PUBLIC HEALTH DIVISION
Drinking Water Services

March 6, 2019

**Re: City of Monmouth (PWS ID#00537)
Cartridge Filtration Plant (PR#77-2017)
Final Approval**

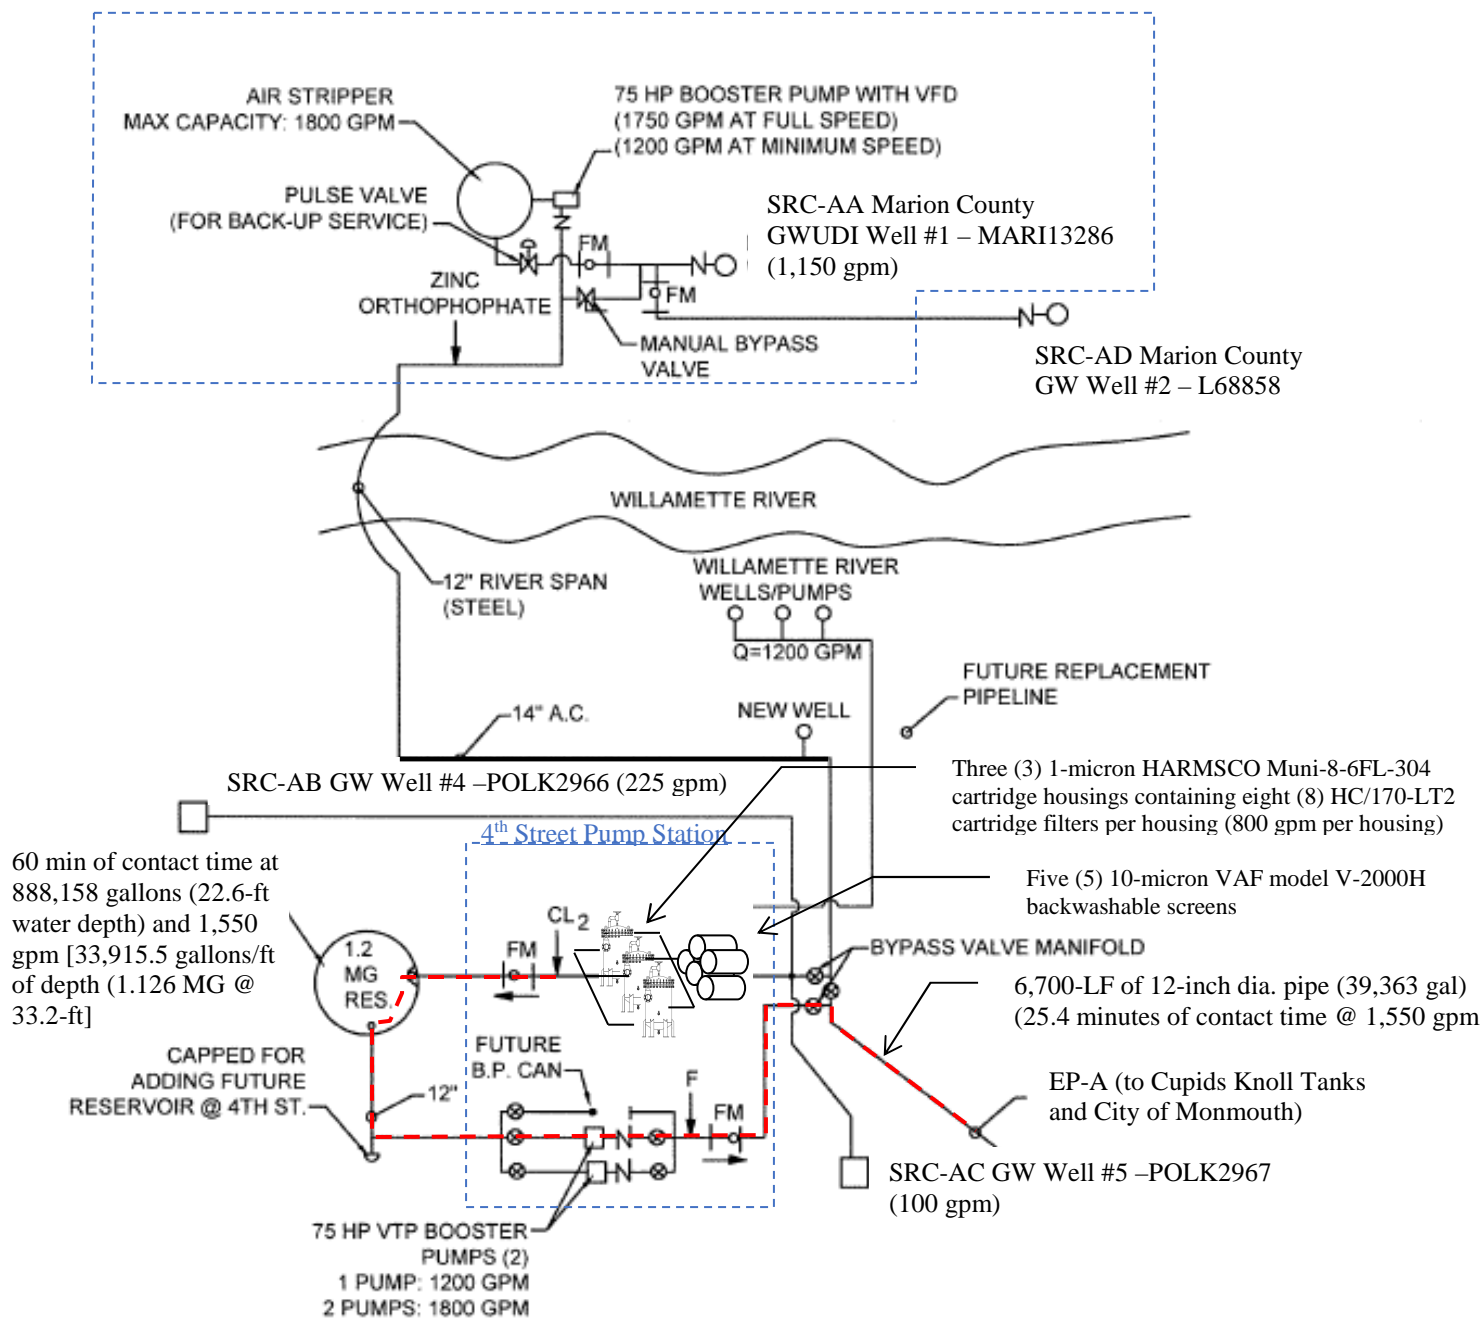
The tracer study completed by OAWU on April 26, 2017 for the 1.2 MG Permastore glass-fused-to-steel tank used for contact time. The tracer study demonstrated a total contact time of 85.4 minutes from the point of injection to the first user. was approved and documented in a letter from our office dated August 17, 2017. The conditions and results of the tracer study are summarized below:

- Total tank volume: 1,250,000 gallons
- Tank volume used for tracer study (min) 861,000 gallons
- Peak Hourly Demand Flow 1,550 gpm
- Measured contact time (T) 60 minutes

(Measured contact time is based on a target chlorine residual of 0.74 mg/L measured at 60 minutes.)

The tracer study results described above are acceptable with the following conditions: A contact time (T) of **85.4 minutes** can be used for the daily contact time (CT) calculations provided the reservoir volume does not drop below 861,000 gallons and the peak hourly demand flow leaving the contact reservoir does not increase over 10 percent of 1,550 gpm.
